Appendix A - Response to Government Agencies and Organisations Submissions

Trinity Grammar School - SSDA 10371
 119 Prospect Road, Summer Hill

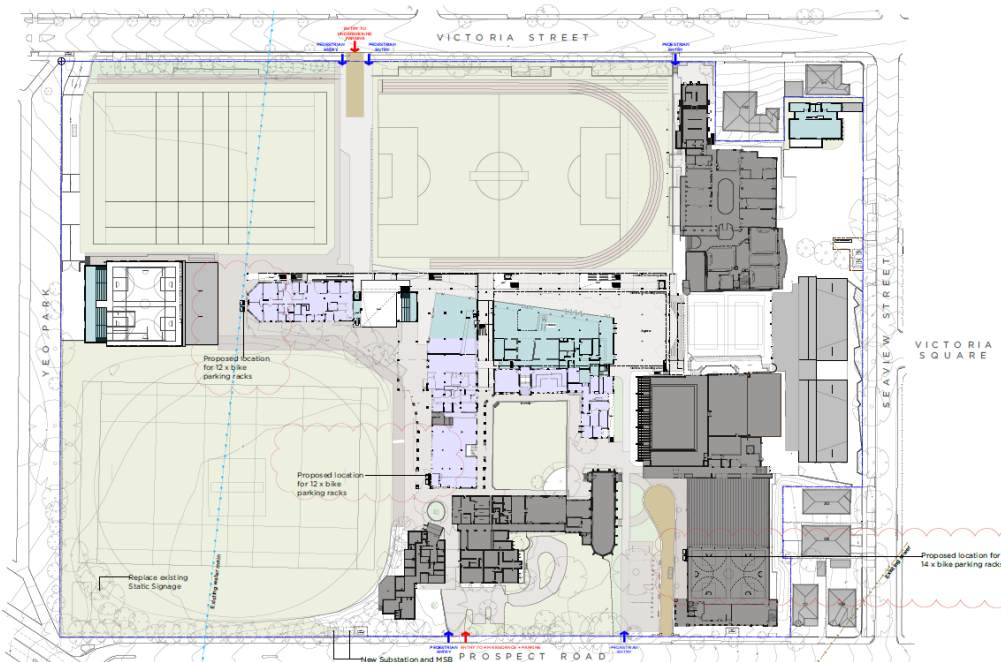
<ul style="list-style-type: none"> The TA report must specify whether the increase in student numbers are to be phased during operation. The associated SIDRA modelling for intersection performances, construction and operational traffic impacts on the surrounding road network must be considered for each phase of increase in student numbers or construction of a new building. 	<p>The proposed development results in an additional 445 students across the Site.</p> <p>As discussed in Appendix H, the increase in student numbers will be phased over a number of years, with each increase generally aligning with the start of the new school year in late January/early February.</p> <p>As previously addressed, construction will also be phased. Stages 1 and 2 will be completed prior to any increase in student population. The proposed staging is a deliberate strategy to ensure that any additional demand for vehicle travel to/from school is captured within the new car park on school grounds to reduce potential for queuing of vehicles on-street.</p>

Table 1. Response to Government Agencies and Organisations Submissions																																																											
Issues Raised	Proponent’s Response																																																										
	<p>Figure 1 below is an extract from Appendix I and illustrates the relationship between student numbers increases and construction phasing.</p>

<p>Figure 1. Relationship between student number increase and construction phasing</p> <p>The SIDRA Future Scenario modelling in the original TA report by TTM Consulting was carried out using assumptions that the full student and staff increases had been reached. However, to meet the Department’s request, additional modelling has been undertaken to demonstrate the effect of the larger student increases between years 2024-2026. This modelling has been carried out by TTM Consulting in Queensland to maintain consistency. Refer to Appendix H.</p> <p>Overall, the student increases and construction phasing will be staged concurrently. As aforementioned, this strategy was adopted to ensure the new car park arrangement prior to student increases to make sure that pick-up/drop-off functions are wholly contained within the Site, subsequently reducing on-street queuing. Additionally, the additional modelling indicated that the phased student increase will have an incremental impact, and that at a full capacity, there is no detrimental impact on the street network when compared with the existing conditions. This will be further supported through the ongoing implementation of the Green Travel Plan.</p>		2023	2024	2025	2026	2027	2028	Student increases	Junior School		+20	+20	+20		Senior School	+40	+40	+40	+40	+40	TOTAL	+40	+60	+60	+60	+40	+40	Construction Staging	Stage 1 & 2 – completed prior to 2023						Stage 3 – General Learning, finish car park						Stage 4 – Performing Arts						Stage 5 – Junior School, landscaping						Stage 6 – Minor works					
	2023	2024	2025	2026	2027	2028																																																					
Student increases	Junior School		+20	+20	+20																																																						
	Senior School	+40	+40	+40	+40	+40																																																					
	TOTAL	+40	+60	+60	+60	+40	+40																																																				
Construction Staging	Stage 1 & 2 – completed prior to 2023																																																										
	Stage 3 – General Learning, finish car park																																																										
	Stage 4 – Performing Arts																																																										
	Stage 5 – Junior School, landscaping																																																										
	Stage 6 – Minor works

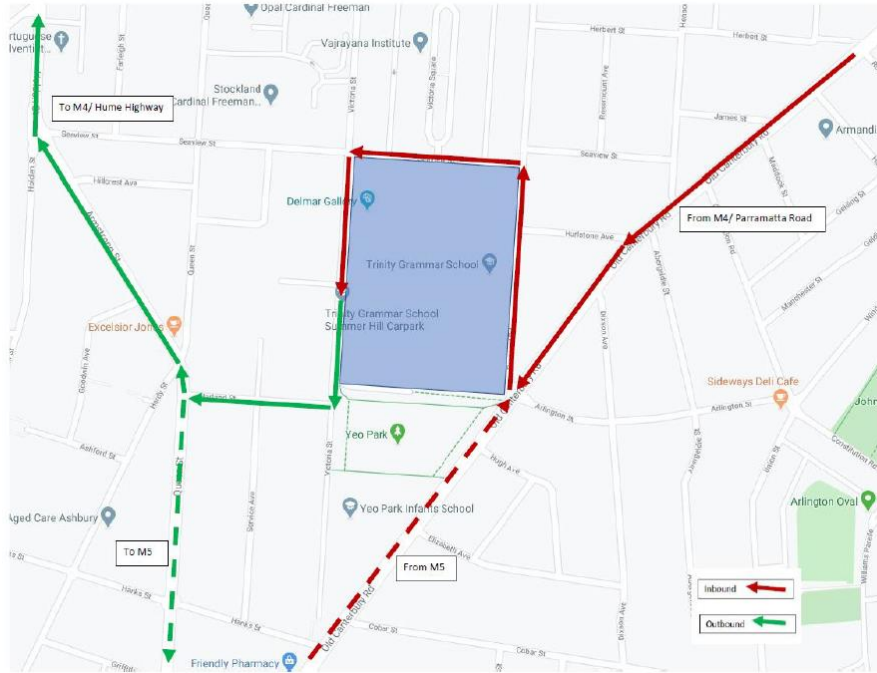
<ul style="list-style-type: none"> It is unclear whether bicycle parking spaces with end of trip facilities are provided on site. Adequate bicycle spaces with end-of-trip facilities should be proposed and identified in the architectural plans. 	<p>Under the original submission, the bicycle parking facility was identified on Drawing No. DA111, located within the basement car park. Access to shower and facilities for the end of trip facility are located in the existing aquatic facility.</p> <p>However, on further assessment, this location for the bike parking is not ideal given that bike riders will need to mix with the car park traffic to access the bike parking. The alternate is to enter the school at ground level, dismount, and walk the bike to the bike parking. These actions are likely to be a disincentive to bike riding.</p> <p>It is proposed to relocate the bike parking so that it is accessible from Prospect Road and closer to the end of trip facilities in the aquatic centre. Three potential locations are proposed, with final placement (or potential to consolidate these options into one or two locations) to be decided during detailed design.</p> <p>The proposed locations are shown in Figure 2 below:</p>

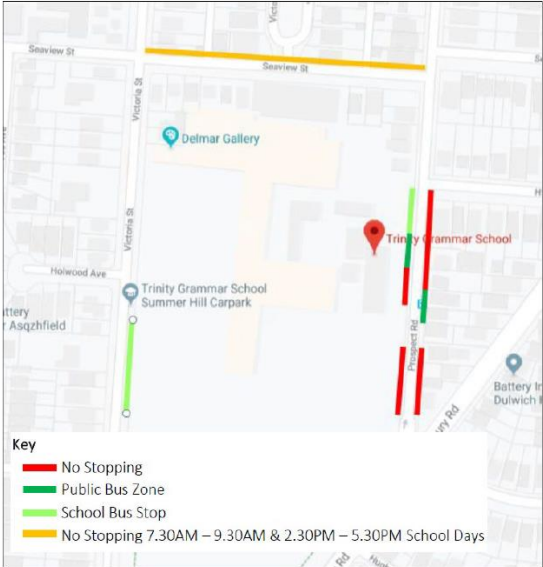
Table 1. Response to Government Agencies and Organisations Submissions	
Issues Raised	Proponent's Response
<ul style="list-style-type: none"> ▪ Details of construction traffic arrival and departure routes should be included in the TA report. The details of truck turning movements (considering the various sizes and the width of the access roads) and any associated issues / pedestrian safety matters in relation to the construction traffic routes must also be identified, noting that the site is located in a residential area. 	<ul style="list-style-type: none"> ▪ Option 1: Chapel Drive ▪ Option 2: Founders Building; and/or ▪ Option 3: New Pavilion Building. <div style="text-align: center; margin: 10px 0;">  </div> <p>Figure 2. Proposed new bike parking location</p> <p>As identified below, the proponent supports the preparation of a Construction Traffic Management Plan (CTMP) being conditioned as part of the consent.</p> <p>The proposed construction vehicle routes are identified in Figure 3 below.</p>

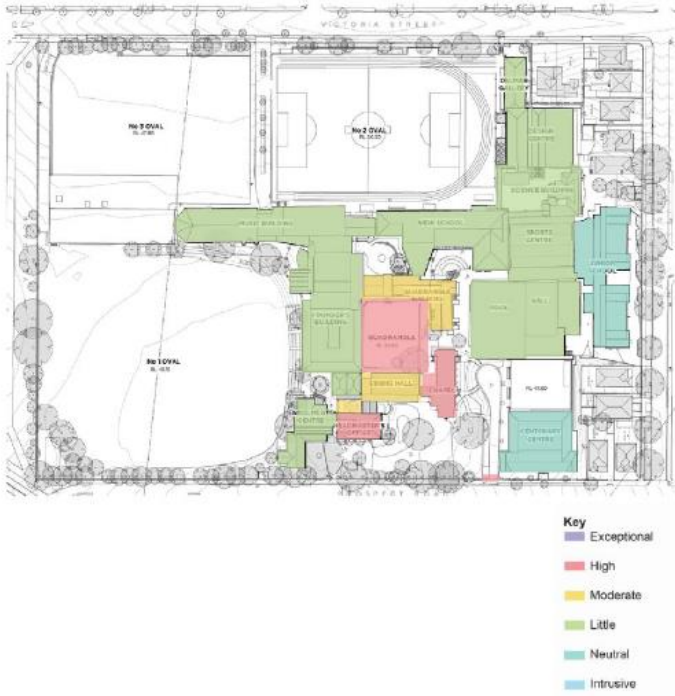
Table 1. Response to Government Agencies and Organisations Submissions	
Issues Raised	Proponent's Response
<p>and consequently does not meet the LEP aims for conserving the environmental heritage of the LGA.</p> <p>The supporting heritage and aboriginal heritage assessments have largely been compiled from secondary sources and neither document contains adequate documentary or physical research regarding the original landscape form. The reports do not demonstrate an understanding of the design and character of the sequence of significant buildings and associated landscaping and quadrangles progressively erected to create the school campus. This sequence of development including buildings and landscaping created for four different educational users including the private school, the NSW Department of Public Instruction (later Department of Education) and the Anglican Church is potentially of state significance. The architects of the various phases include the most significant designers of school buildings in the State.</p> <p>The conclusions of the HIS are not supported by Inner West Council's Heritage Specialists. Today interwar and post war works of architecture and landscape are also considered to be of cultural significance, and should have been assessed in relation to both the Collegiate Gothic and Tudor Revival tradition in School Architecture in Australia and in terms of the introduction of modern architectural trends in School Architecture (based on criticism of using historic motifs for the chapel in the mid 1950s).</p> <p>Inner West Council had established the heritage significance of three elements within the complex: the Chapel; the Headmaster's Residence and the gates in its Ashfield Heritage Study and the listings also mention the quadrangle. This inventory was undertaken in 1991/92 for Council by highly respected heritage consultants however the listing information has not been included in the SSD application (despite being provided by Council's heritage specialists).</p> <p>The Heritage Assessment does not contain sufficient documentary or physical evidence to support a change in the level of significance from</p>	<p>In summary amendments to the HIS include the following:</p> <ul style="list-style-type: none"> ▪ Minor additions to history to reflect updated research. ▪ Inclusion of known architects – this has been the focus of additional research, and has been assisted by Dr. Noni Boyd from Inner West Council. ▪ Further identification of the significant elements across the Site. ▪ Acknowledgements and limitation section – acknowledging the contribution of previous reporting and Dr Noni Boyd, as well as the limitations on research including poor record keeping post-war and the Covid-19 pandemic. <p>As part of the preparation of the amended HIS, further investigations were undertaken to determine the significance of the heritage items across the Site. It is concluded that the significant elements on the Site constitute the Headmasters House and grounds and the War Memorial Chapel. It is also considered that the following elements make a defining contribution to the significance of the Site overall, all with a high grading of significance, and should be retained:</p> <ul style="list-style-type: none"> ▪ Headmaster's Residence and Chapel Garden; ▪ Chapel Gates and Way; ▪ War Memorial Chapel Court; ▪ Dining Hall; ▪ Presentation of the North Quad. <p>Figure 6 below illustrates the gradings of significance for buildings across the Site.</p>
